No. 14449. CUSTOMS CONVENTION ON CONTAINERS, 1972. CONCLUDED AT GENEVA ON 2 DECEMBER 1972¹

ENTRY INTO FORCE of amendments to annexes 4 and 6 to the above-mentioned Convention

*Amendments to annexes 4 and 6
of the Customs Convention on Containers, 1972*

ANNEX 4—Sketch No. 2 (a)

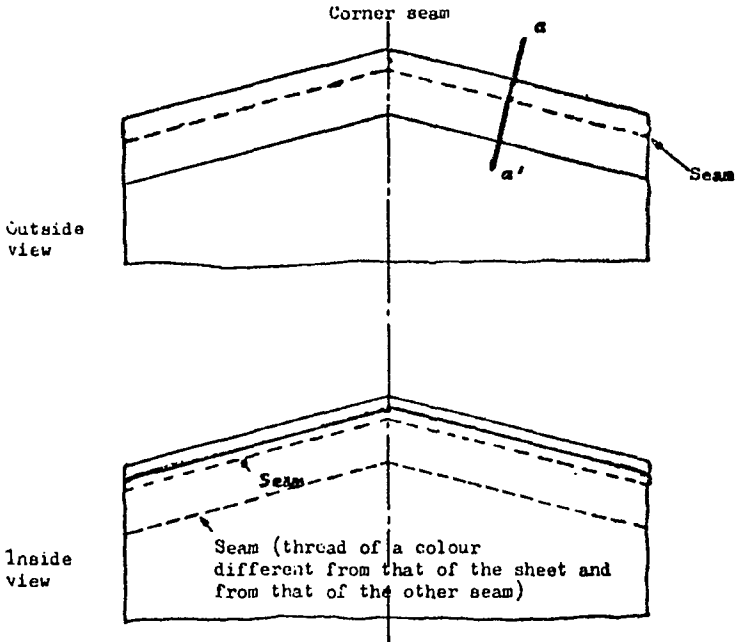
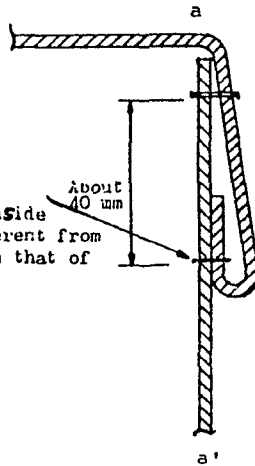
1. *Annex 4, article 4, paragraph 3:*

Amend the second sentence to read as follows:

“These seams shall be made as shown in sketch No. 1 appended to these Regulations; however, where in the case of certain parts of the sheet (such as flaps and reinforced corners) it is not possible to assemble the pieces in that way, it shall be sufficient to fold the edge of the top section and make the seams as shown in sketches Nos. 2 or 2 (a) appended to these Regulations.”

Insert a new sketch No. 2 (a) in annex 4 (attached as appendix 1 to the present annex).

ANNEX 6—Sketch No. 4

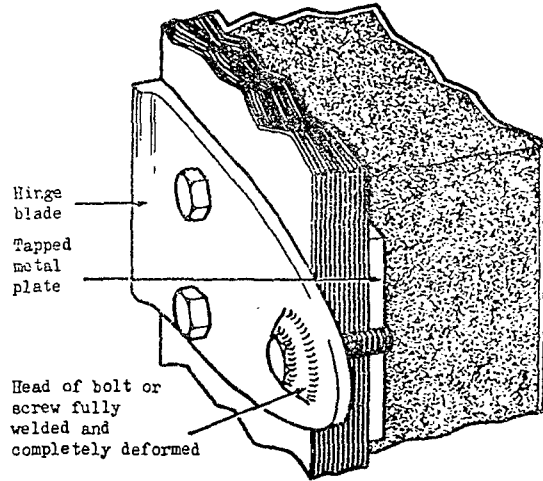
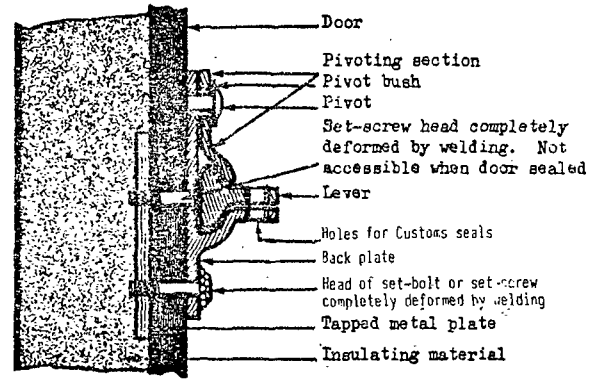
5. *Annex 6, explanatory note 4.2.1.(b)-1:*

Add a new subparagraph (c) to the explanatory note 4.2.1. (b)-1 as follows:

“Exceptionally, in the case of insulated containers only, the Customs sealing device, the hinges and any fittings, the removal of which would give access to the interior of the

container or to spaces in which goods could be concealed, may be fixed to the doors of such containers by means of set bolts or set screws which are inserted from the outside but which do not otherwise meet the requirements of subparagraph (a) of the explanatory note to annex 4, article 2, paragraph 1 (a) on condition that:

- “(i) The tails of the set bolts or set screws are fixed into a tapping plate or similar device fitted behind the outer layer or layers of the door structure; and
- “(ii) The heads of an appropriate number of set bolts or set screws are so welded to the Customs sealing device, hinges, etc., that they are completely deformed and that the set bolts or set screws cannot be removed without leaving visible signs of tampering (see sketch No. 4 to this Annex).

The present subparagraphs (c) and (d) will become subparagraphs (d) and (e) respectively. Insert a new sketch No. 4 in annex 6 (attached as appendix 2 to the present annex).

ANNEX 6—Sketch No. 5

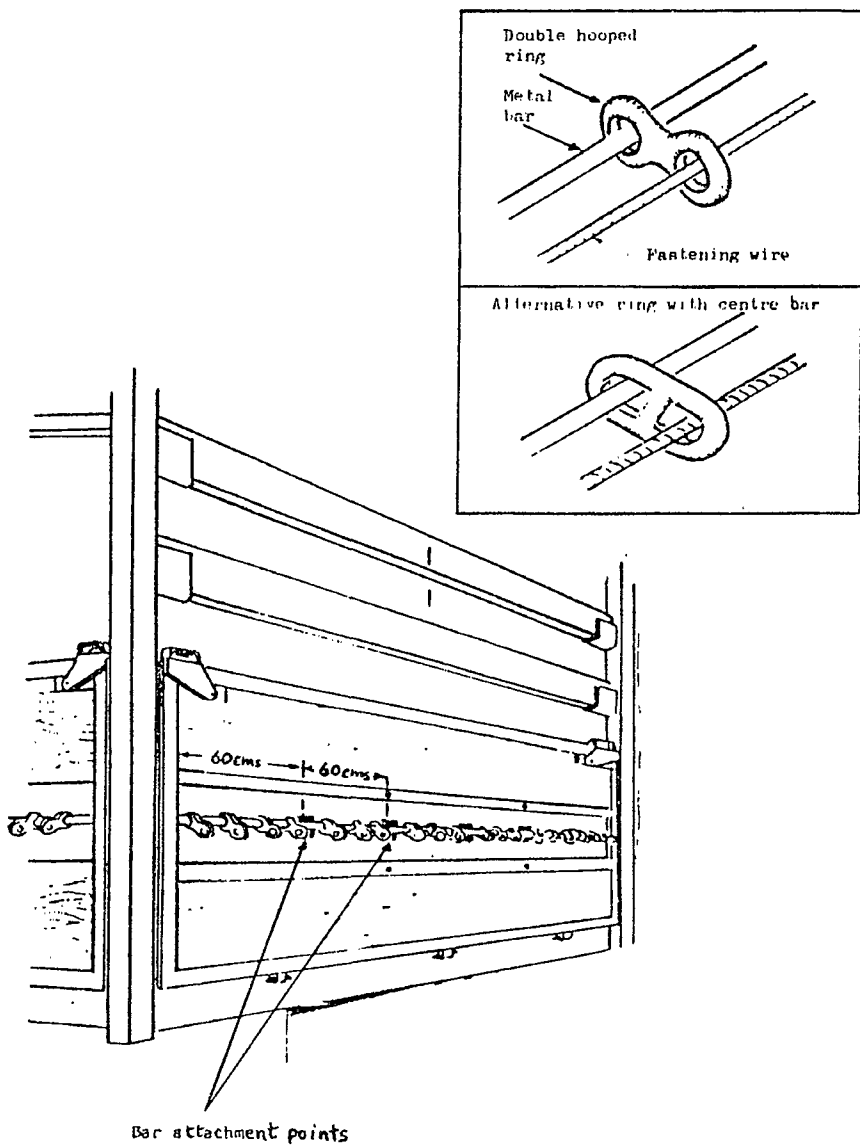
Add a new explanatory note 4.4.6.(a)-2, as follows:

“*Subparagraph 6. (a) (i) — Sheeted containers with sliding rings*

“4.4.6.(a)-2. Metal securing rings sliding on metal bars fixed to the containers are acceptable for the purposes of this paragraph (see sketch No. 5 appended to this annex) provided that:

- “(a) The bars are affixed to the container at maximum spacings of 60 cm and in such a manner that they cannot be removed and replaced without leaving obvious traces;
- “(b) The rings are made with a double hoop or equipped with a central bar and made in one piece without the use of welding; and
- “(c) The sheet is fixed to the container in strict compliance with the conditions set forth in annex 4, article 1 (a) of this Convention.”

Insert a new sketch No. 5 in annex 6 (attached as appendix 3 to the present annex).
